A Road Safety Audit

New Mexico Department of Transportation (NMDOT)

Guadalupe Street from Agua Fria to Paseo de Peralta

NMDOT District 5
December 2014

Countermeasure—Pedestrian Refuge, Extend Median to south to Agua Fria

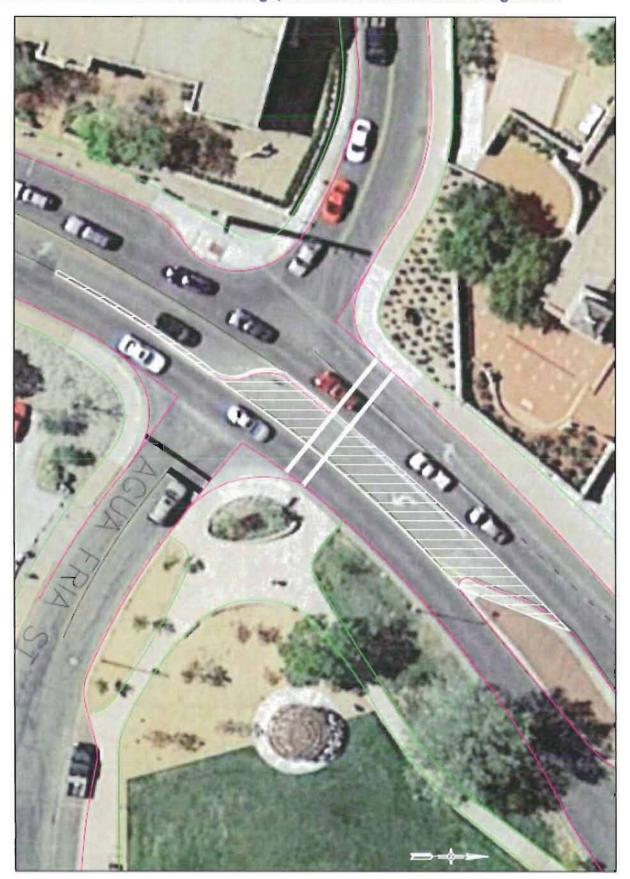
Suggestion: Construct two crosswalks with median islands, overhead flashers, signing, pavement markings etc. where there is not a nearby traffic signal and there is a history of pedestrian activity. Possible locations include at Agua Fria or just north of it, and just south of the Johnson Intersection. The median island would need to be of a width of at least 4 feet.

Extending the full width median that is located on the north side of Agua Fria to the south would eliminate the southbound left turn lane onto Agua Fria. However, the traffic volumes for this movement are light and account for only 1.3 percent of the total approach volumes

Countermeasure— Four Lanes to Three Lanes, "Road Diet"

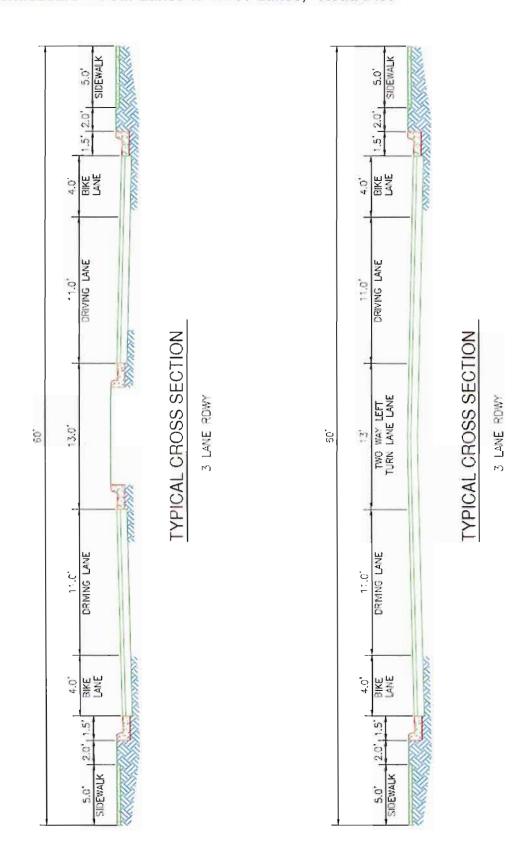
Suggestion: Convert the existing four lane roadway typical into a three lane roadway typical. The typical section would be two through lanes and a center two-way left turn lane and/or raised medians with center left turn lanes. Bicycle lanes and pedestrian crossing islands could then be added to the corridor. Additionally, wider sidewalks could then be installed.

The southern 2/3 of Guadalupe Street under review currently had a very narrow raised median. Therefore, introducing a three lane typical with a raised median in this area would possibly be met with less resistance from businesses/property owners in the area.

The three lane typical would end on the south side of the Paseo de Peralta intersection.

This typical does decrease the LOS for the northbound and southbound movements on Guadalupe Street.
